Product Bulletin

New And Improved Control Housing

A Design Change Has Been Made To The RC Monitor Control Housing.

Front Face of Enclosure

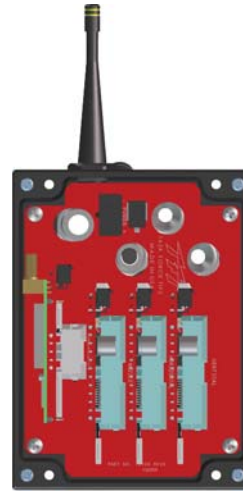
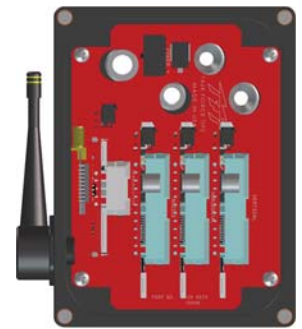
FEATURES	BENEFITS
Retrofit	Mount to existing brackets
Antenna Placement (Reduce Overall Height)	Helps reduce accidental damage to antenna
Thicker Walls	Protect against impact damage
Dovetail O-ring Groove	O-ring is retained in groove, does not fall out
Standard O-ring	Improves sealing capabilities
